Request for Additional Information No. 541(6322), Revision 0, Supplement 2

U. S. EPR Standard Design Certification

Docket No. 52-020

Question 02-3:**OPEN ITEM****New Phase 4 RAI**

Figure 2.3-1—U.S. EPR Release Points, ~~and~~ Control Room Air Intakes, and Unfiltered Inleakage Locations

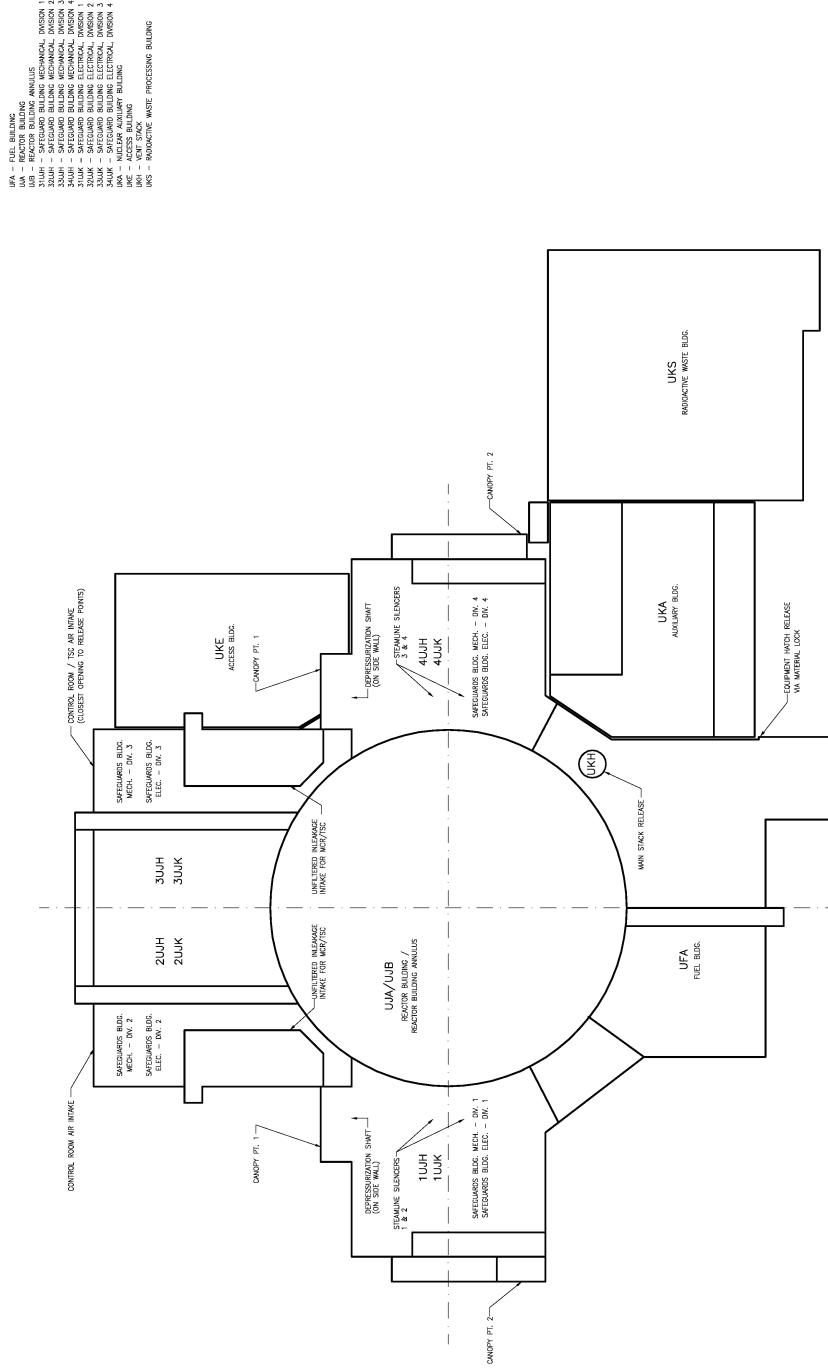
U.S. EPR FSAR Tier 2, Sections 2.3, 3.3.1, and 3.3.2, and Figure 2.3-1 will be revised as described in the response and indicated on the enclosed markup.

All indicated changes are in response to RAI 541, Supplement 2, Question 02-3
